# Amendment Notice 4

**Licence Number** L4496/1988/11

**Licence Holder** Big Bell Gold Operations Pty Ltd

**Date of Amendment** 24 July 2019

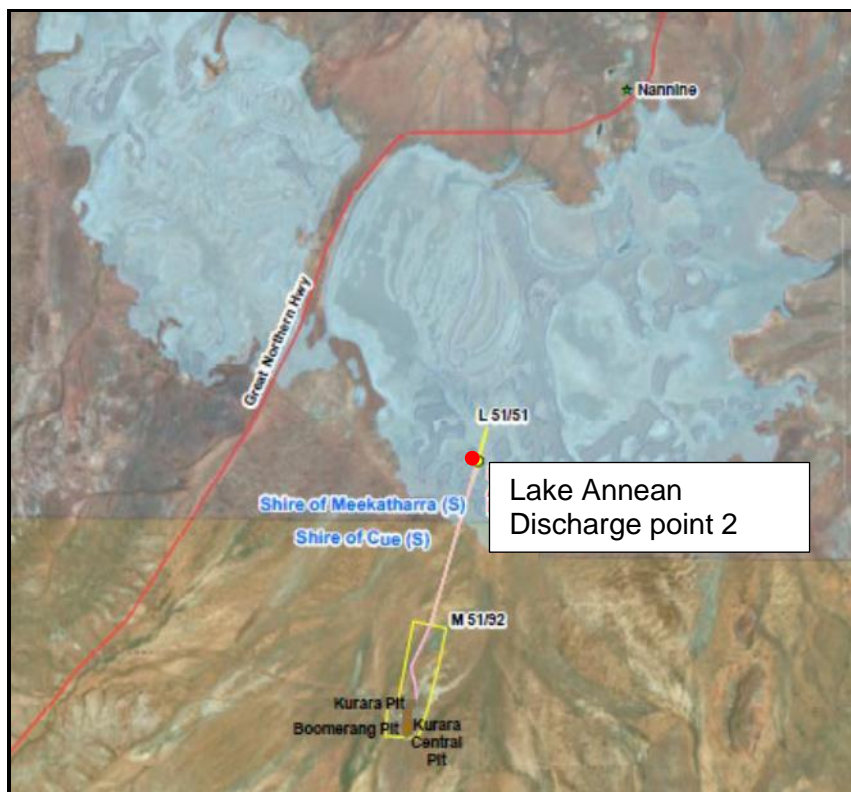
9. The Licence is amended by the insertion of the map below into Schedule 1 Map of emission points:
